**Item No. 9.1.1**  
**Design Review Committee**  
**February 8, 2018**

**SUBJECT:** **Case 21461: Substantive Site Plan Approval – 1451 & 1435 Hollis Street, Halifax**

Application by WSP Canada Inc. for substantive site plan approval to enable the development of an 8 storey residential building at the southeast corner of Bishop Street and Hollis Street, Halifax.

Governor's Plaza Plan Level 7

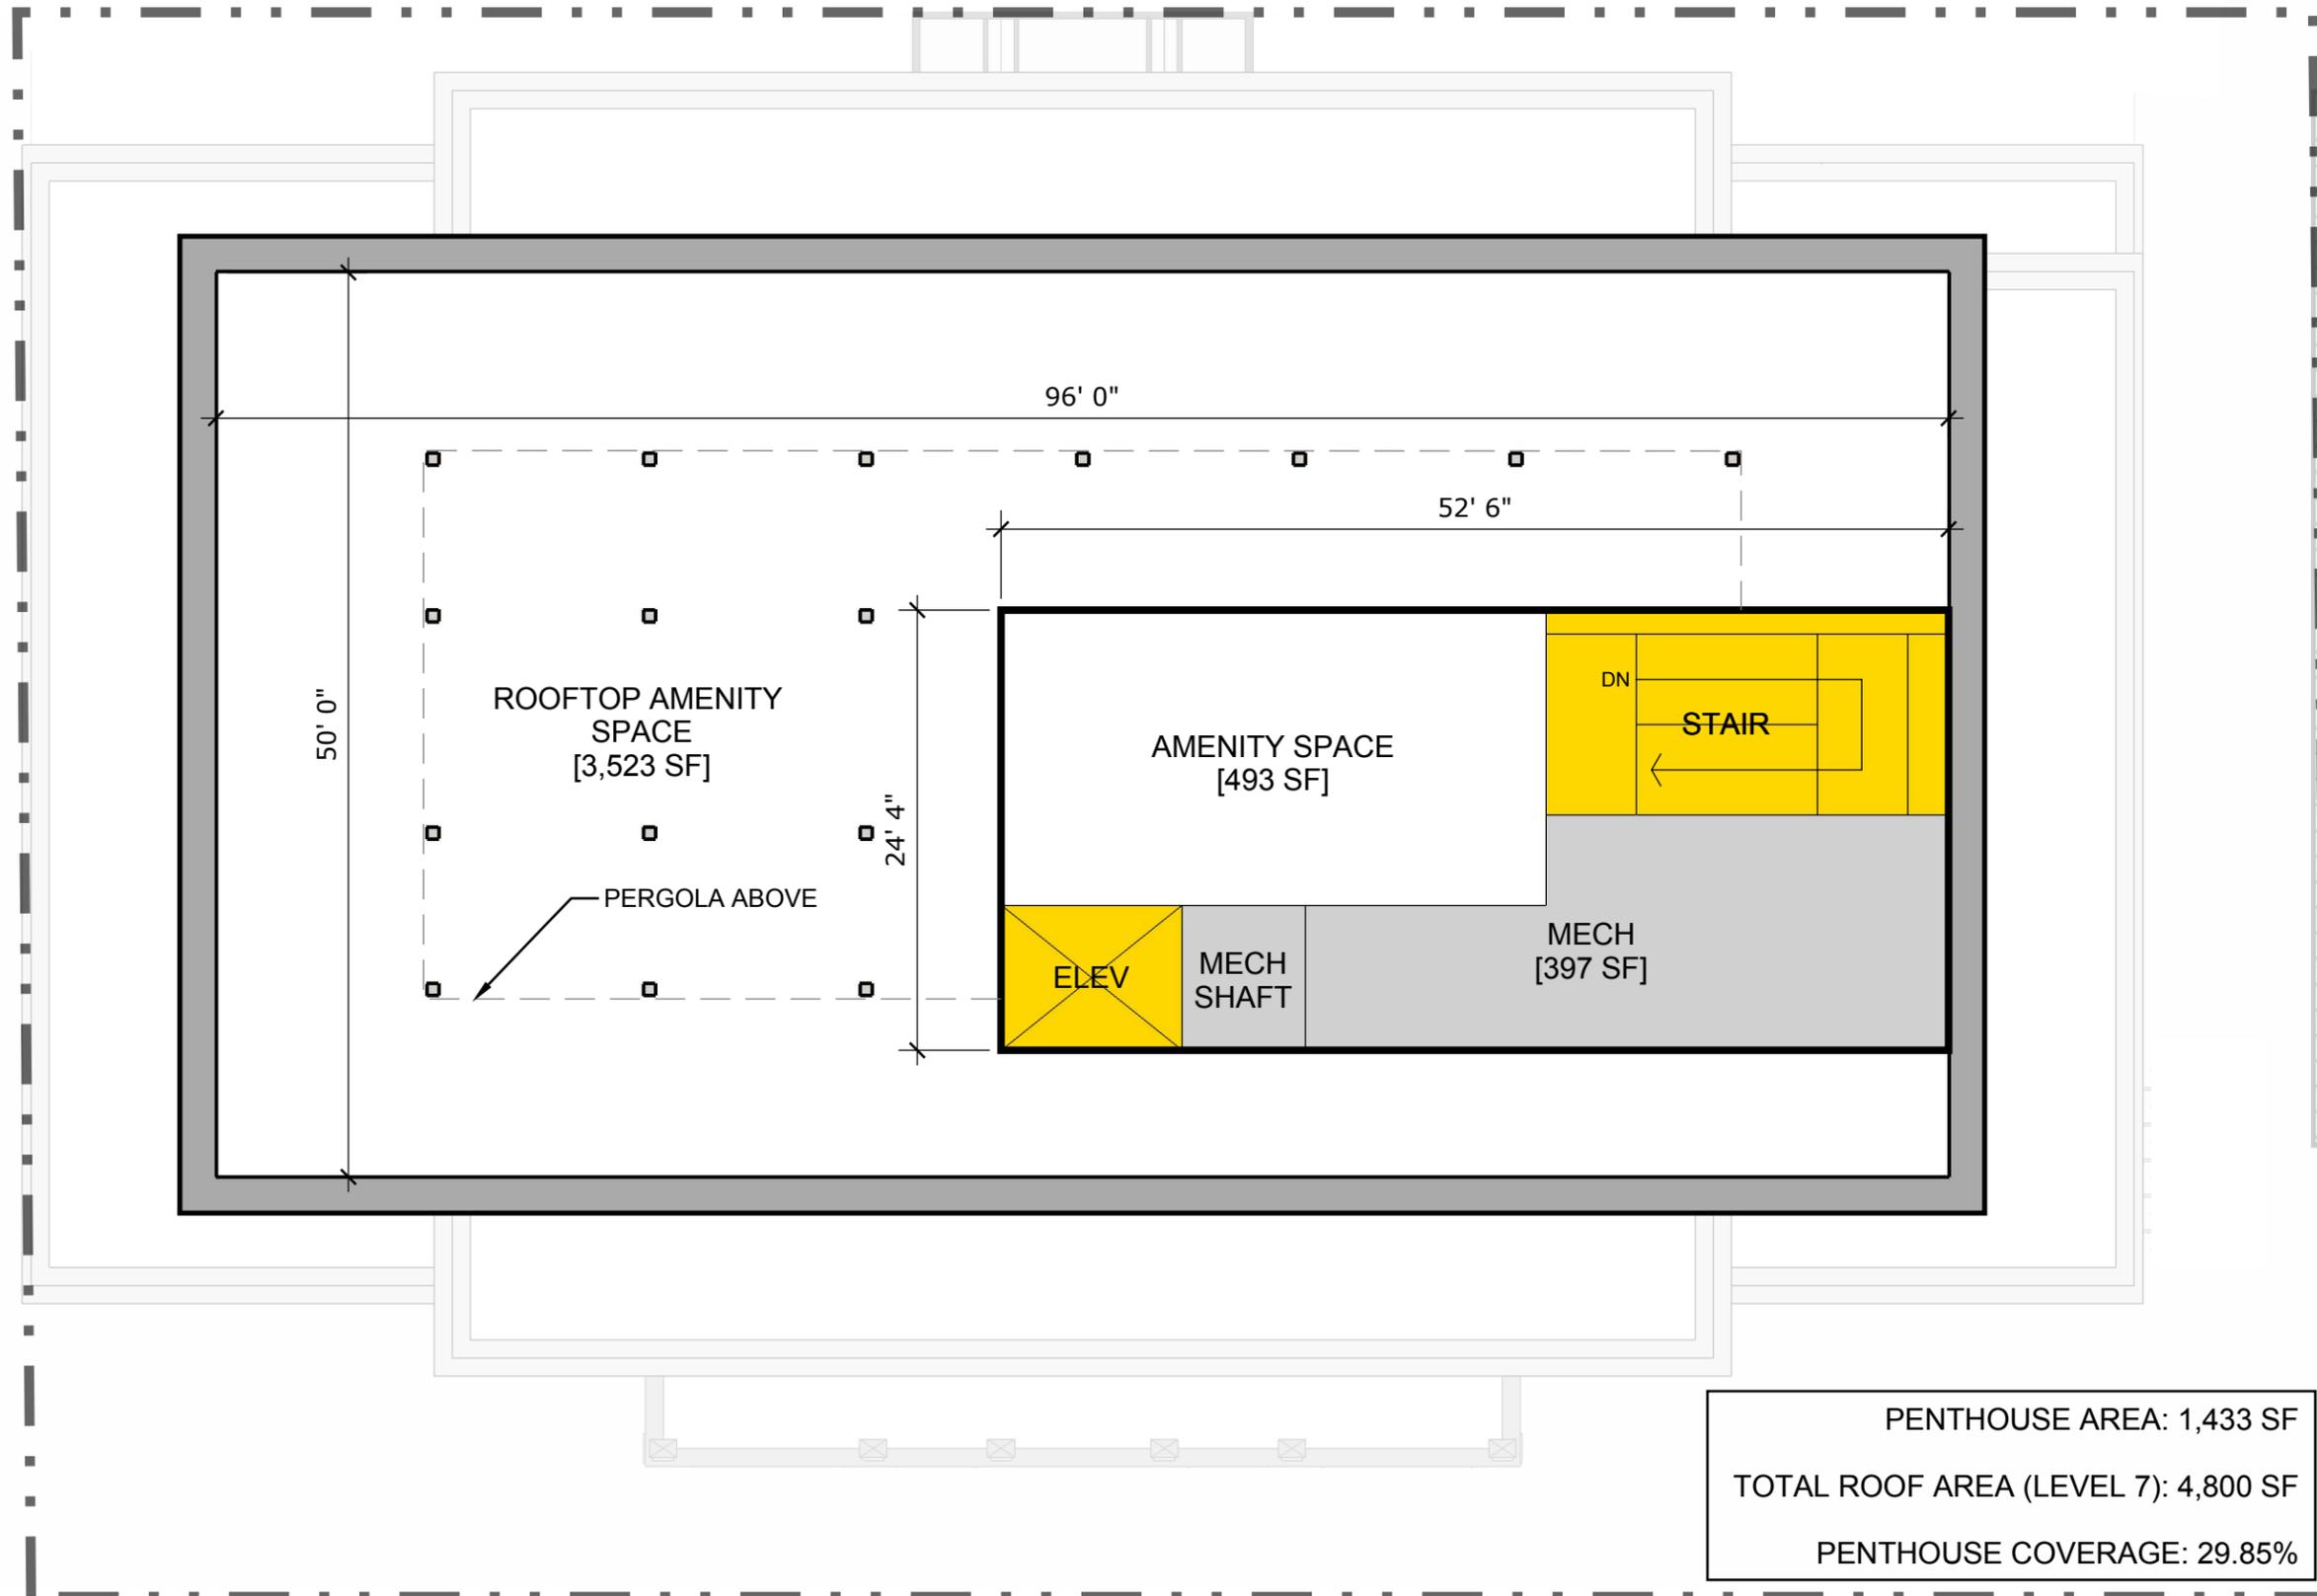
Section 8(10) of the LUB stipulates that rooftop features be setback no less than 3 metres from the outer most edge of the roof. In this case, a penthouse containing an amenity room, stairs, elevator, and mechanical space will have no setback from the southern roofline and approximately 2.75 meter setback from the eastern roofline. Further, a glass guardrail measuring approximately 1 metre in height is proposed along the entire roof edge of the 8<sup>th</sup> level.

The proposed variance for the penthouse setback is largely due to the location of the building's stairwell. As per the applicant's submission, due to the separation provided between the proposed building and the adjacent heritage property as suggested in the Design Manual, the egress stairwell must be located as shown. The requested variance is on internal property lines only and will not have a significant impact on views from the street.

# Governor's Plaza Roof Terrace Amenity Space

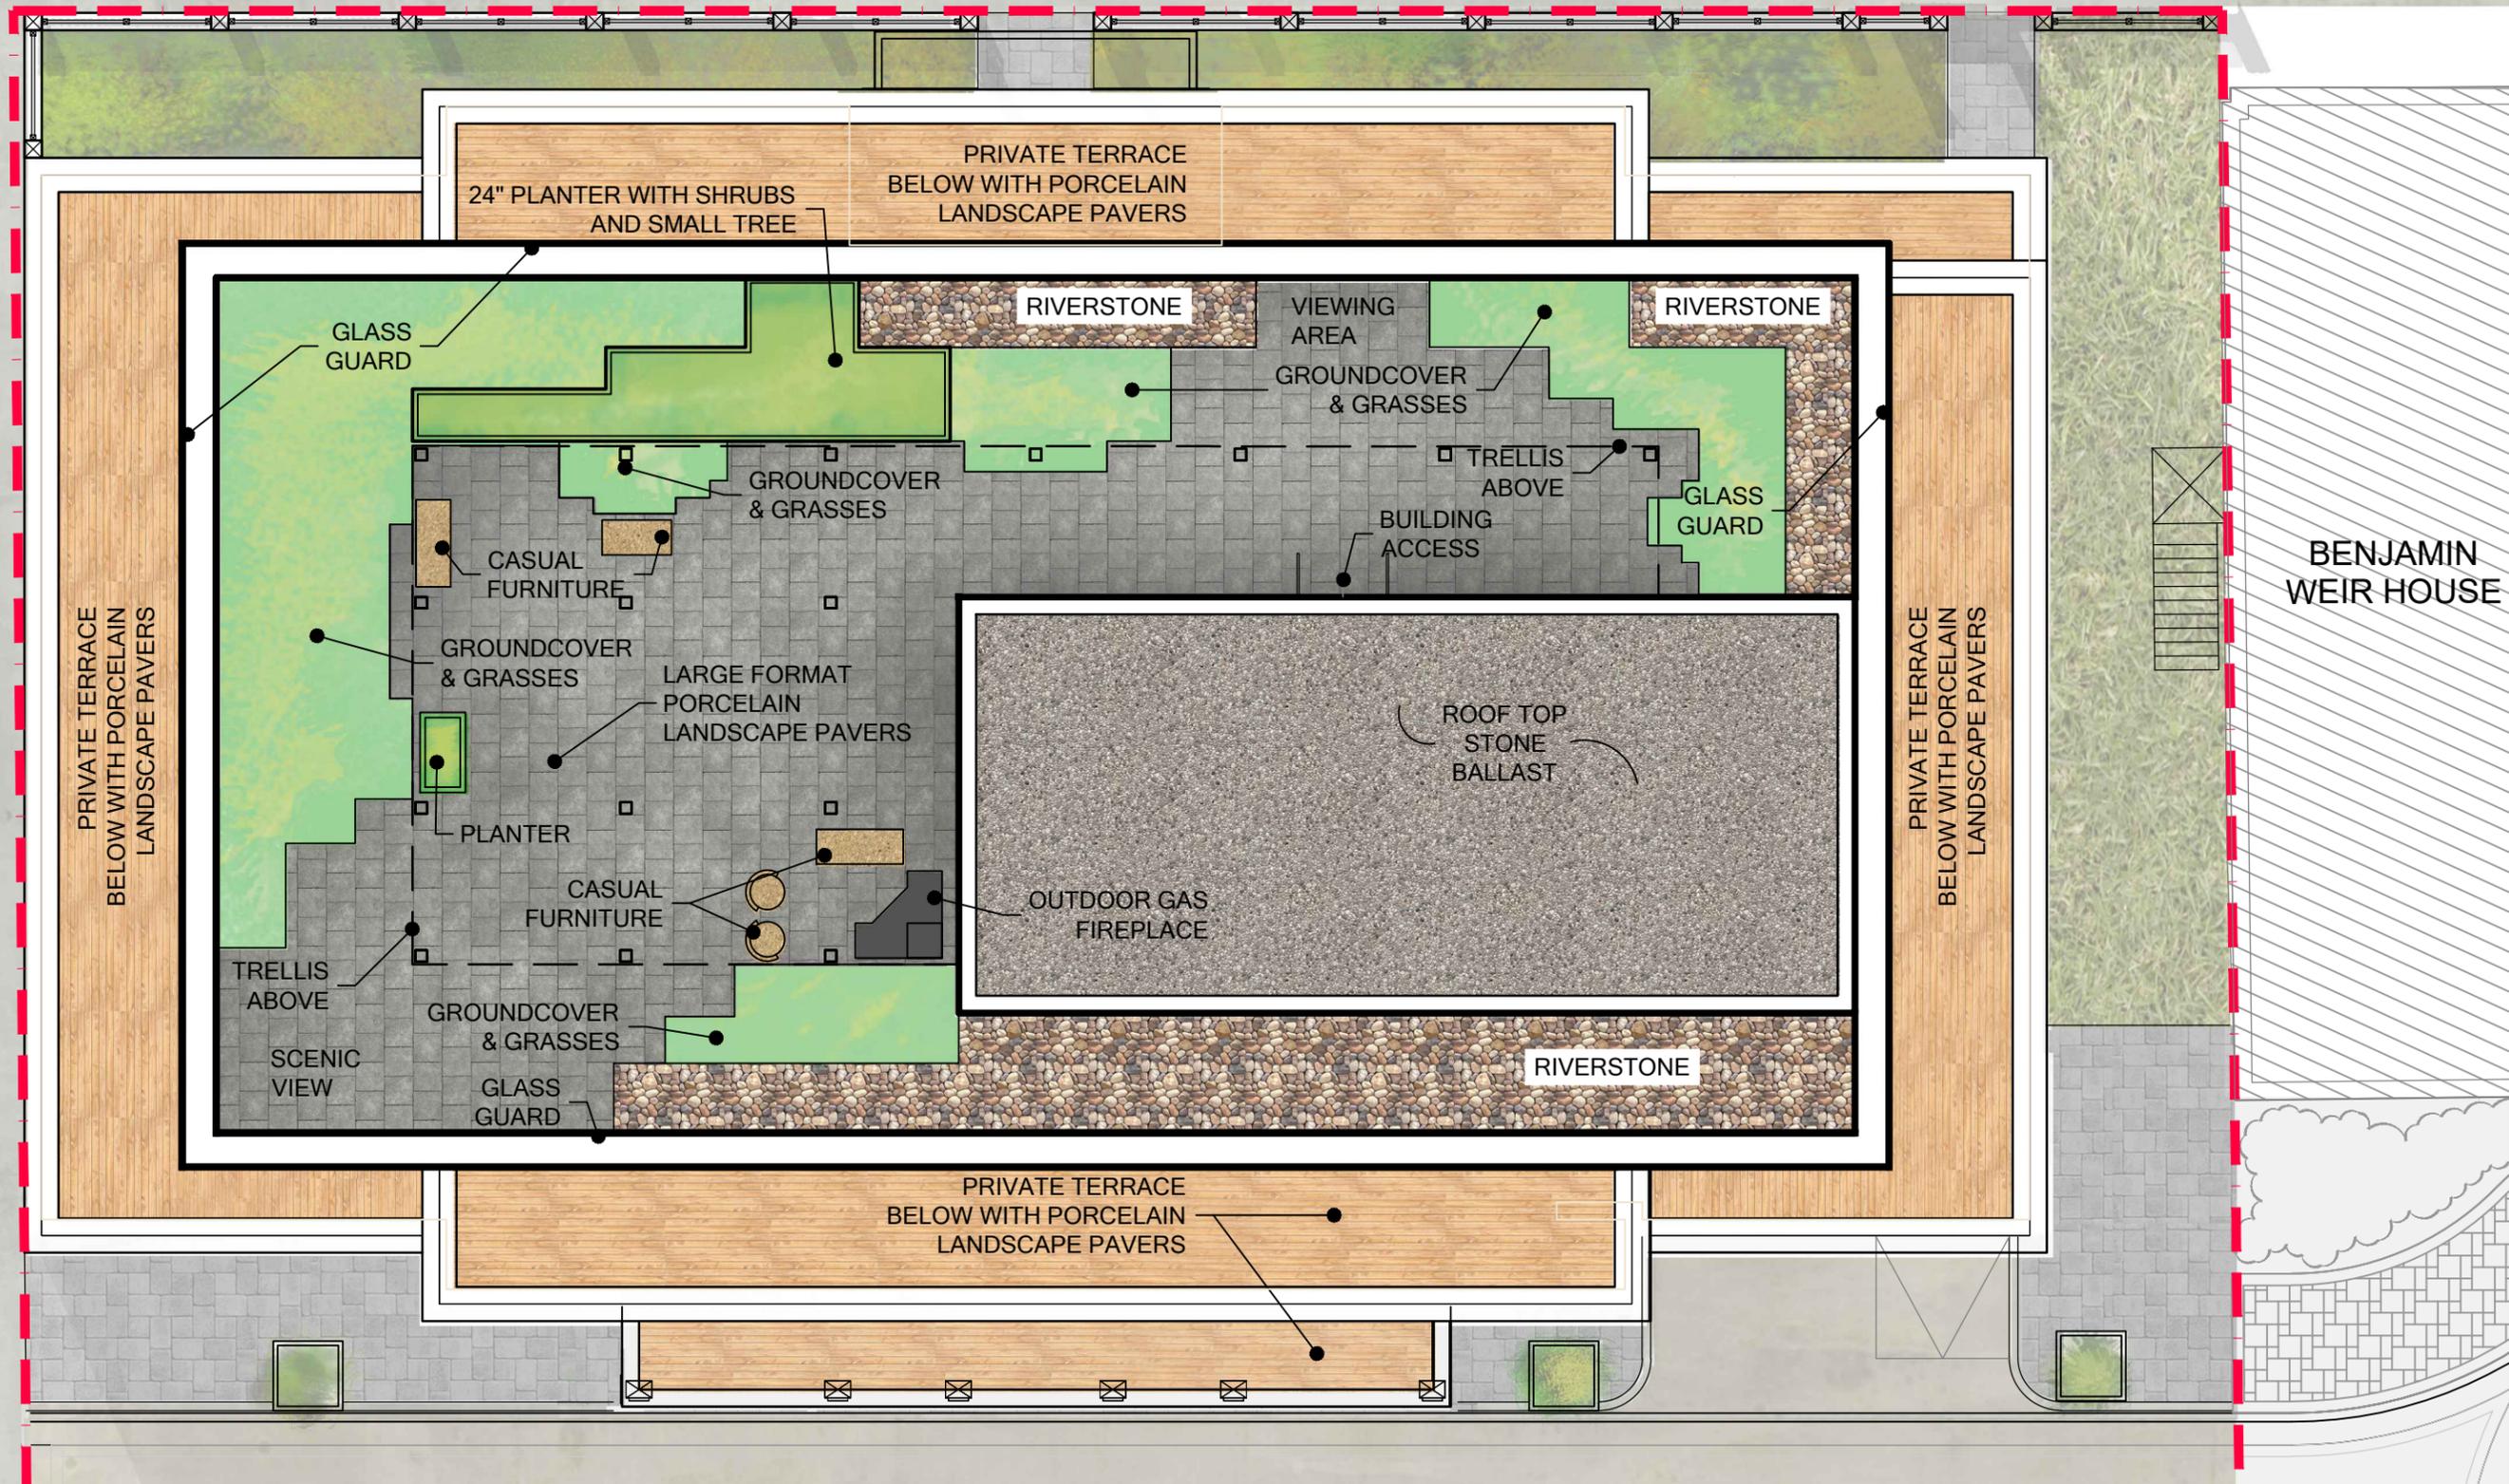
1. The proposed rooftop amenity space would have wind conditions that are not ideal for seating areas. Local landscape features and a taller guardrail are recommended to mitigate these effects. The applicant has provided a revised landscaping plan taking these suggestions into consideration. Although the guardrail remains unchanged, planters have been located to the west of proposed seating areas to better mitigate winds, as recommended by the wind study.
2. The wind conditions along the Bishop Street and Hollis Street sidewalks are appropriate except at the southwest corner where they will be uncomfortable during winter months. However, as noted in the wind study, this is typical at street intersections in Halifax during the winter; and
3. Wind conditions at building entrances are acceptable.
